Access Compliance Report

Public Rights-of-Way

Intersection ID: 11775	Main Street: E_18TH_ST	Cross Street: SEIGLE_AV	Location: W
ADA ID: 962B2B77988E	Ramp Type: Perp	Initial Pass/Fail: Fail	Overall Compliance: No
		Severity Score: 25

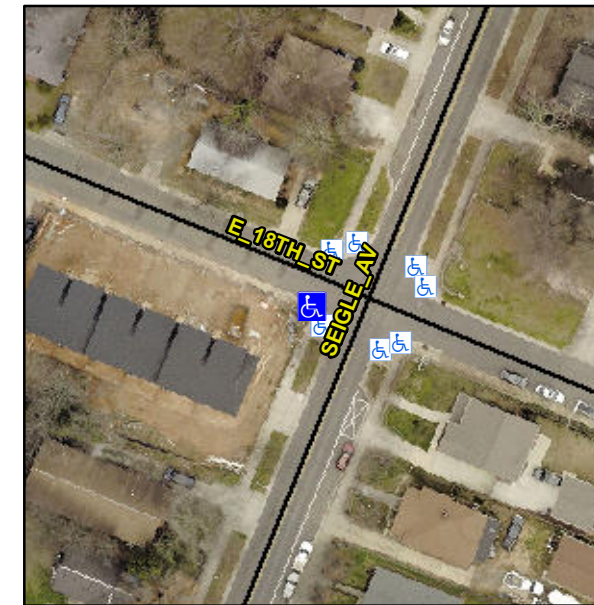
Not Found, R304.5.3

Compliance	Description	Data	Compliance	Description	Data
N/A	Ramp Length (in)	57.0	Yes	Ramp Slope (%)	5.0
Yes	Ramp Width (in)	50.0	No	Ramp XSlope (%)	8.4
N/A	Flare Type LT	N/A	N/A	Flare Type RT	N/A
N/A	Flare Slope LT (%)	N/A	N/A	Flare Slope RT (%)	N/A
N/A	Flare Traversable LT?	N/A	N/A	Flare Traversable RT?	N/A
N/A	Landing Length (in)	N/A	N/A	DWS Provided?	N/A
N/A	Landing Width (in)	N/A	N/A	DWS Contrast?	N/A
N/A	Landing Slope (%)	N/A	N/A	DWS Length (in)	N/A
N/A	Landing X Slope (%)	N/A	N/A	DWS Full Width?	N/A
N/A	Landing Curb? (Y/N)	N/A	N/A	DWS Offset (in)	N/A
N/A	Shared Landing?	N/A			
N/A	Gutter Ponding?	N/A	N/A	Gutter Slope (%)	N/A
N/A	Gutter Lip Ht (in)	0.75	N/A	Gutter X Slope (%)	N/A
N/A	Painted X Walk1?	No	N/A	Painted X Walk2?	N/A
	X Walk 1 Direction	To NE		X Walk 2 Direction	N/A
N/A	X Walk 1 Width (in)	N/A	N/A	X Walk 2 Width (in)	N/A
	X Walk 1 Slope (%)	2.2		X Walk 2 Slope (%)	N/A
	X Walk 1 X Slope (%)	8.4		X Walk 2 X Slope (%)	N/A

Remove & Replace Entire Ramp.
